Technical News Bulletin

Steinhausen, August 2015

Constant Cushion Blowhead, 210-1533

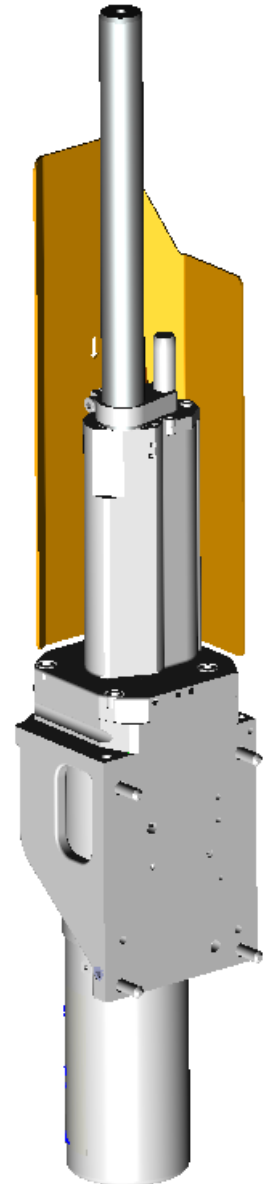
- Longer cooling tubes and improved internal container cooling enables increased blow mold contact time and higher machine performance.
- Improved motion cushioning for increased lifetime.
- Exchangeable oil cushioned cartridge without removing mechanism.

Faster machine speeds, heavier Blowhead arms and requirement for longer cooling tubes has drove the development to introduce the large CC Blowhead mechanism. Longer cooling tubes and improved internal container cooling enables increased blow mold contact time and higher machine performance. It uses oil cushioning for the up-stroke and can be retrofit for all large Emhart machines.

An existing Blowhead mechanism can be replaced with the CC Blowhead mechanism. Supporting Bracket requires alignment and need to be drilled and pinned to section frame.
